AMENDMENT UNDER 37 CFR § 1.111
Serial No. 09/577,814

REMARKS/ARGUMENTS

FIG. 1

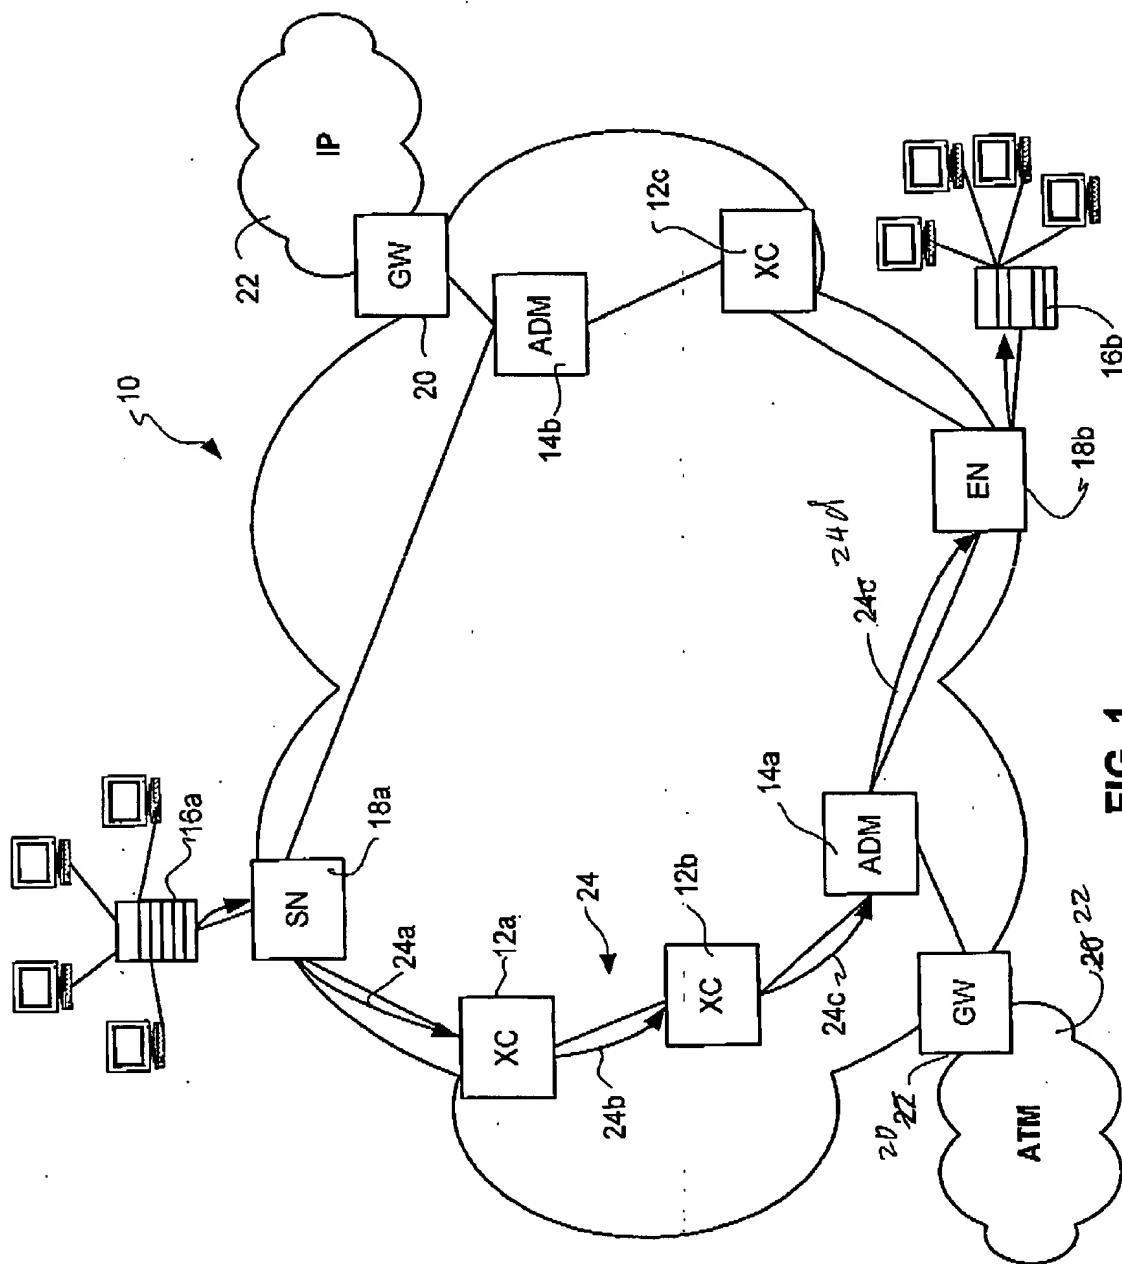
By way of the above-noted amendments, original independent claims 1, 19 and 31 have been amended to more clearly define features of the present invention. Dependent claims 2-5, 14, 20, 22, 25 and 28 have been amended to reflect the revisions effected in claims 1 and 19, and to more clearly define features of the present invention. No disclaimer of subject matter is implied by these revisions, which are presented for clarity only. The specification has been amended at page 1 to properly identify related applications. Further revisions have been effected in pages 2, 5, 7, 14, 16, 17, 22, 23, 29, 34 and 35 of the specification to correct typographical errors identified therein. Finally, figures 1, 3, 4 and 5 are proposed to be amended in order to correct inconsistencies identified therein.

FIG. 3

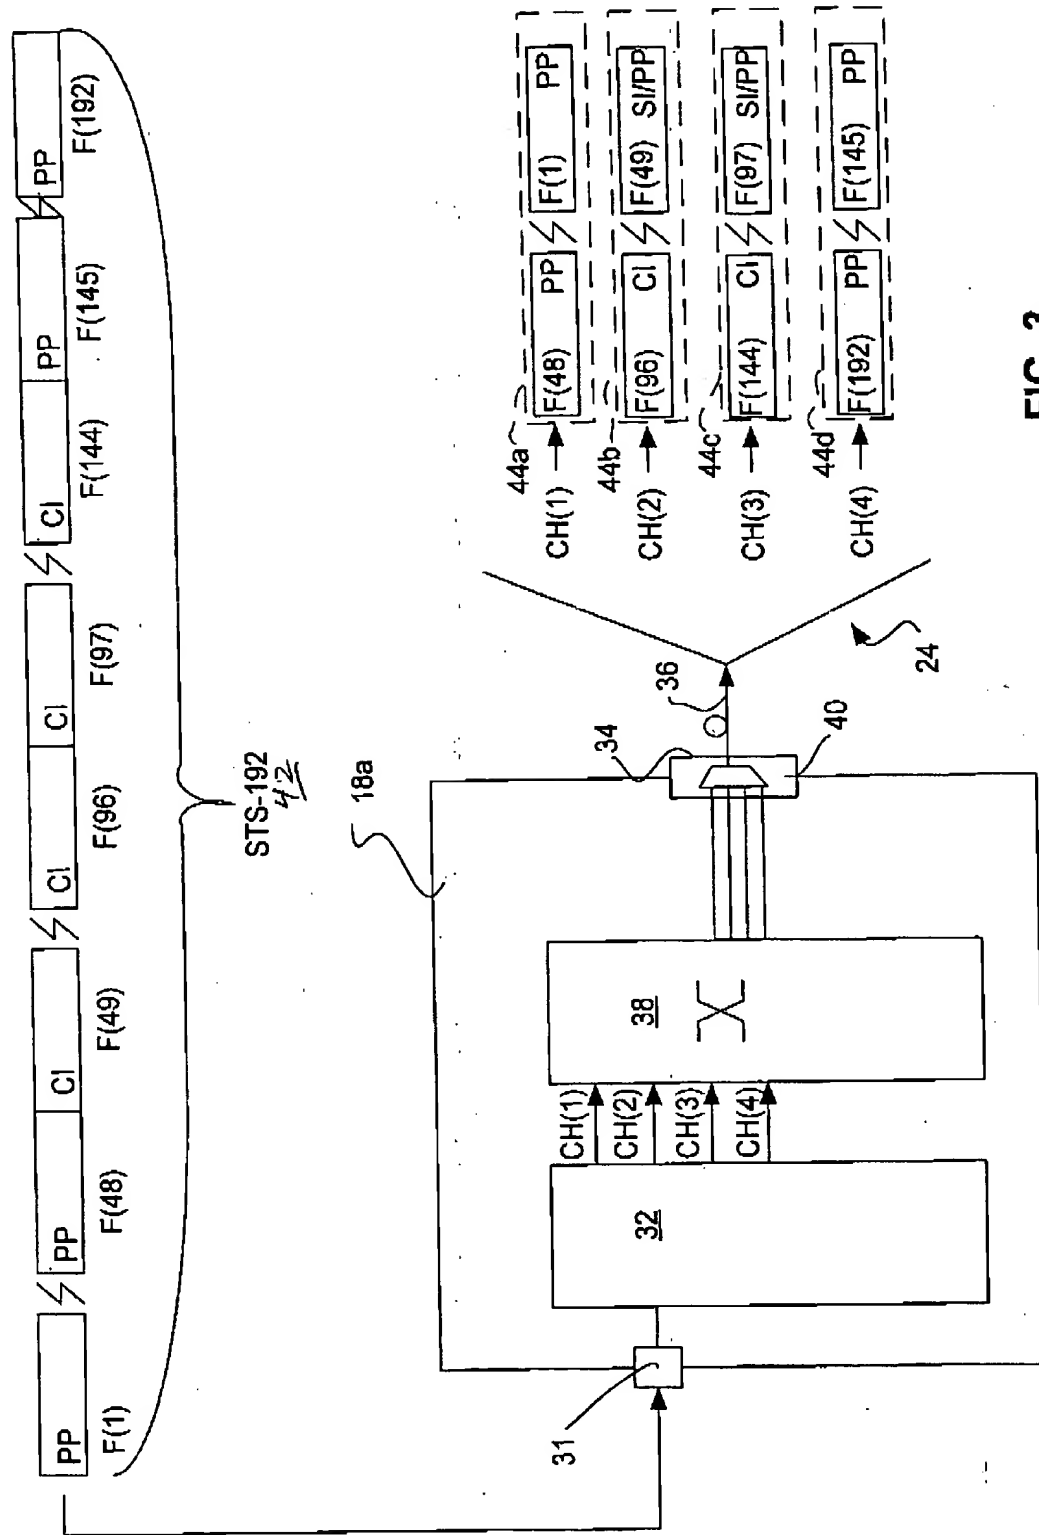
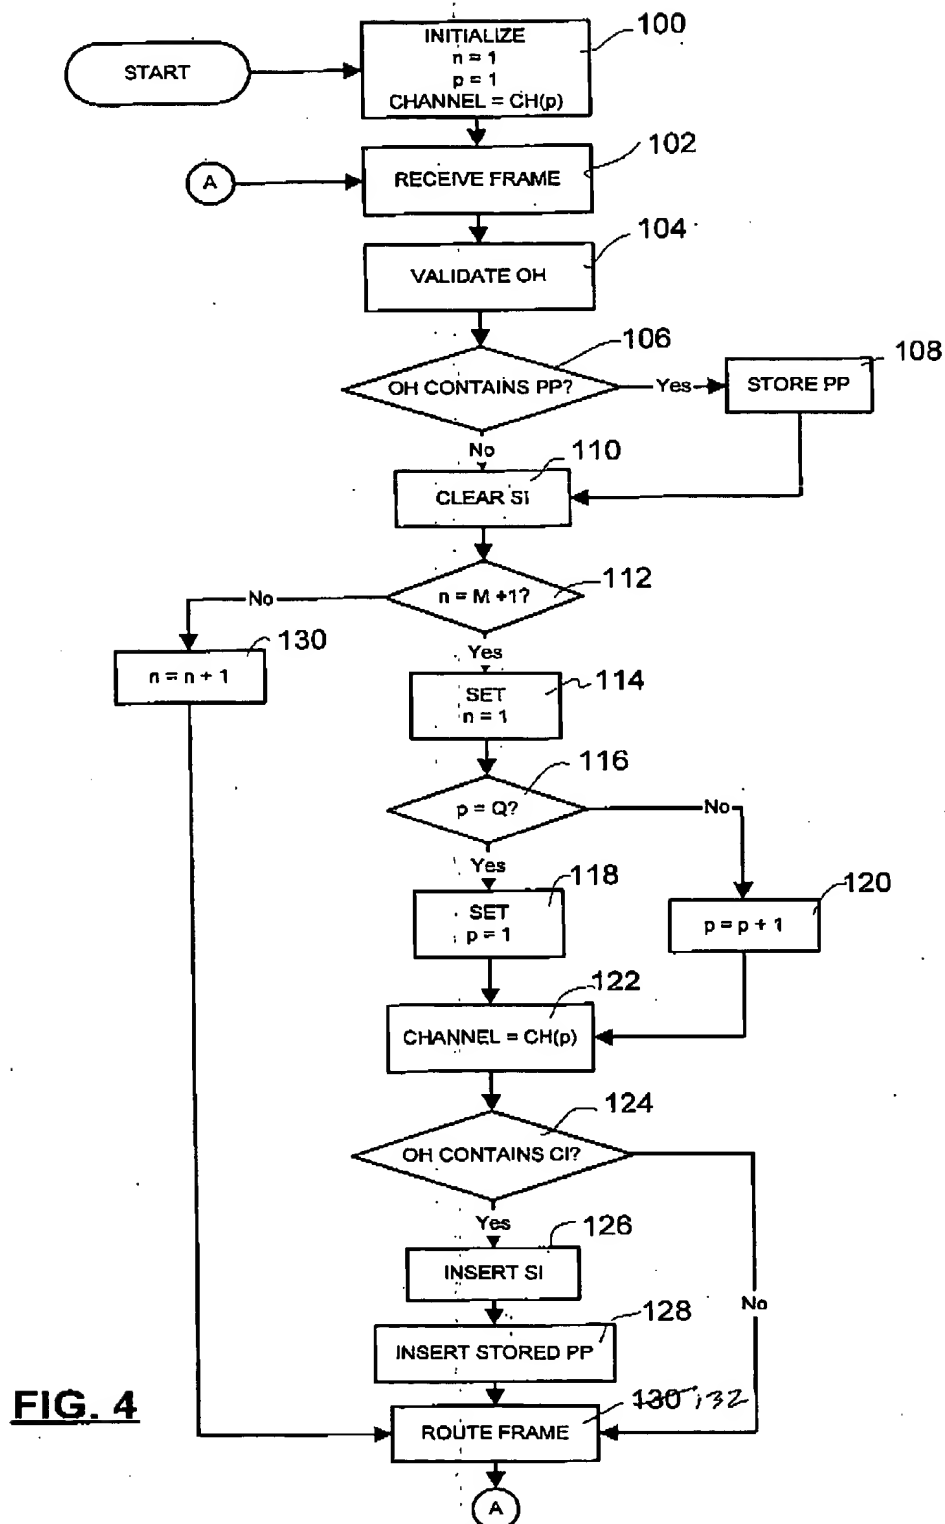
As shown in Fig. 3, the signal processor 32 receives a serial concatenated data stream containing an arbitrary mix of low bandwidth signals and high bandwidth concatenated signals. The serial data stream may be received through a single input port 31, as shown, or may be distributed across two or more ports. The signal processor 32 is designed to process the serial data stream to split the respective signals across the multiple channels of the hyper-concatenated connection 24, in accordance with the channel assignments associated with the hyper-concatenated connection 24. . (Underlining added)
